Access Compliance Report

Public Rights-of-Way

(Curb Ramps)

Intersection ID: 10023633	Main Street: CLOSEBURN_RD	Cross Street: N/A	Location: N
ADA ID: F3202342C3DB	Ramp Type: PerpDiag	Initial Pass/Fail: Fail	Overall Compliance: No
			Severity Score: 21.25

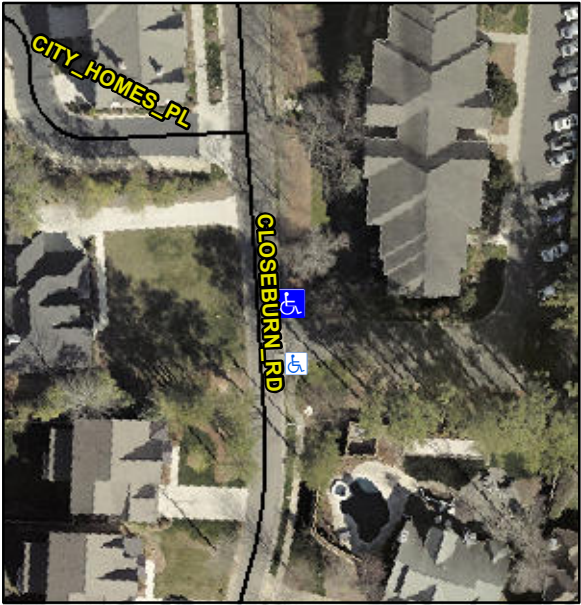
Codes/Mitigation Info/Possible Solution			Field Measurements/Component Compliance		
	Possible Solutions:		Compliance	Description	Data
	Remove & Replace Curb Ramp With Two New Directional Ramps or Equivalent.		N/A	Ramp Length (in)	31.0
			No	Ramp Width (in)	46.0
			N/A	Flare Type LT	N/A
			N/A	Flare Slope LT (%)	N/A
			N/A	Flare Traversable LT?	N/A
			N/A	Landing Length (in)	N/A
			N/A	Landing Width (in)	N/A
			N/A	Landing Slope (%)	N/A
			N/A	Landing X Slope (%)	N/A
			N/A	Landing Curb? (Y/N)	N/A
			N/A	Shared Landing?	N/A
			N/A	Gutter Ponding?	N/A
			N/A	Gutter Lip Ht (in)	N/A
			N/A	Painted X Walk1?	No
				X Walk 1 Direction	To W
			N/A	X Walk 1 Width (in)	N/A
				X Walk 1 Slope (%)	2.7
				X Walk 1 X Slope (%)	3.9
			N/A	Ramp inside XWalk1?	N/A
<p>Surveyor Notes:</p> <p>N/A</p> <p>PROW/ADA:</p> <p>Not Found, R304.5.1, R304.5.3</p>			N/A	Flare Type RT	N/A
			N/A	Flare Slope RT (%)	N/A
			N/A	Flare Traversable RT?	N/A

N/A	DWS Provided?	N/A
			N/A	DWS Contrast?	N/A
			N/A	DWS Length (in)	N/A
			N/A	DWS Full Width?	N/A
			N/A	DWS Offset (in)	N/A
			N/A	Gutter Slope (%)	N/A
			N/A	Gutter X Slope (%)	N/A
			N/A	Painted X Walk2?	No
				X Walk 2 Direction	To S
			N/A	X Walk 2 Width (in)	N/A
				X Walk 2 Slope (%)	2.2
				X Walk 2 X Slope (%)	2.0
			N/A	Ramp inside XWalk2?	N/A
			N/A	Clear Space?	N/A
			N/A	Clear Space to XWalk (in)	N/A
			N/A	Storm Grate/Utility Hazard?	N/A
				Storm Grate/Utility Type	
			N/A		N/A
			Yes	Surface Condition? (G/P)	Good
Street 1 Name	CLOSEBURN RD				
Stop Condition-Street 2	None				
Street 2 Name	ENTRANCE				
Stop Condition-Street 1	None				
Total Cost:	\$	3200.00
